Working Party on Lighting and Light-Signalling

Device UN Regulations: UN Regulation No. 149 (Road illumination devices)

Proposal for a Supplement to the 01 series of amendments to UN Regulation No. 149

Submitted by the experts from the International Automotive Lighting and Light-Signalling Expert Group *

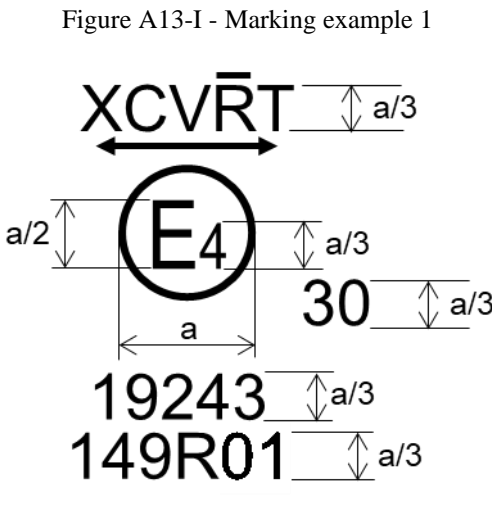
Annex 13, Figure A13-I, amend to read:

<p>Figure A13-I - Marking example 1</p>  <p>a = see Par. 3.3.1.2.1. of this Regulation</p>	<p>The device bearing the approval marking shown on the left is an installation unit of an AFS approved in the Netherlands (E4) under approval number 19243 pursuant to this Regulation.</p> <p>The number after 149R indicates that approval was granted in accordance with the requirements of this Regulation as amended by the 01 series of amendments in its original form (00).</p> <p>The functions identification symbols show that the approval was granted in respect of the driving beam (R) and the Class C and Class V passing beam. The double pointed arrow shows that the passing beam is suitable for both traffic systems by means of an appropriate adjustment of the setting of the optical element or the light source on the vehicle. Class C passing beam, Class V passing beam and driving beam comply to bend lighting provisions, as indicated by the letter "T". The score above the letter "R" indicates that the driving beam function is provided by more than one installation unit on that side of the system.</p> <p>Number 30 indicates that the maximum luminous intensity of the driving beam is between 1.24·10⁵ and 1.45·10⁵ 123,625 and 145,125 candelas.</p>

“Figure A13-III
Marking example 3-a

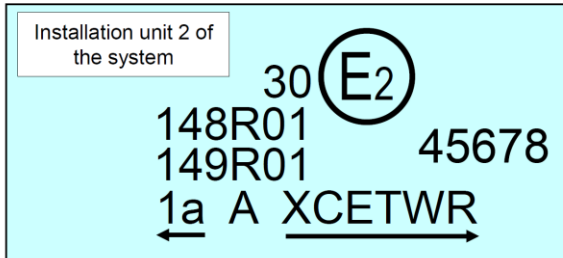
Annex 13, Figure A13-III, amend to read:

Note: The examples 3-a and 3-b in Figure A13-III correspond to a lighting device bearing an approval marking comprising:

- (a) A front position lamp approved in accordance with the ~~0100~~ series of amendments to UN Regulation No. 148. The horizontal arrow indicates the side on which the required photometric specifications are met up to an angle of 80° H;

- (b) A **passing beam headlamp**, of Class **CB**, designed for right-hand traffic only and a driving beam, of **Class B** with a maximum intensity comprised between ~~1.24·10⁵ and 1.45·10⁵~~ ~~123,625 and 145,125~~ candelas (as indicated by the number 30), approved in accordance with the requirements of this Regulation, as amended by the ~~0100~~ series of amendments and incorporating a lens of plastic material;

- (c) A front fog lamp approved in accordance with the ~~0100~~ series of amendments of this Regulation and incorporating a lens of plastic material;
- (d) A front direction indicator lamp of category 1a approved in accordance with the ~~0100~~ series of amendments to UN Regulation No. 148. ”

“Figure A13-IV
Marking example 4

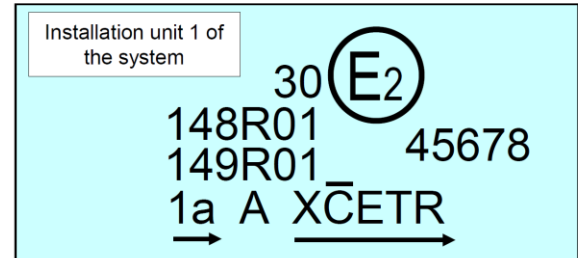
Annex 13, Figure A13-IV, amend to read:

The system bearing the above approval markings meets the requirements of this Regulation (**01 series of amendments to original version of** the Regulation) in respect of both a passing beam for left-hand traffic and a driving beam with a maximum intensity comprised between **$1.24 \cdot 10^5$ and $1.45 \cdot 10^5$** ~~123,625 and 145,125~~ candelas (as indicated by the number 30) grouped with a front direction indicator lamp of category 1a and a front position lamp approved in accordance with the **0100** series of amendments of UN Regulation No. 148.

The installation unit 1 of the system (left side) is designed to contribute to the Class C passing beam and the Class E passing beam. The score above the letter "C" indicates that on that side more than one installation unit contributes to the Class C passing beam. The letter "T" to the right following the listed symbols indicates that each, the Class C passing beam and the Class E passing beam are providing a bending mode.

The installation unit 3 of the system (left side) is designed to provide the second part of the Class C passing beam of that side (as indicated by the score above the letter "C") and a Class W passing beam. For this additional lighting unit, a circle surrounding the letter "E" followed by the distinguishing number of the country is not necessary.

The installation unit 2 of the system (right side) is designed to contribute to the Class C passing beam, a Class E passing beam, both with bending mode and a Class W passing beam.

Note: In the above example, the different installation units of the system shall bear the same approval number. ”
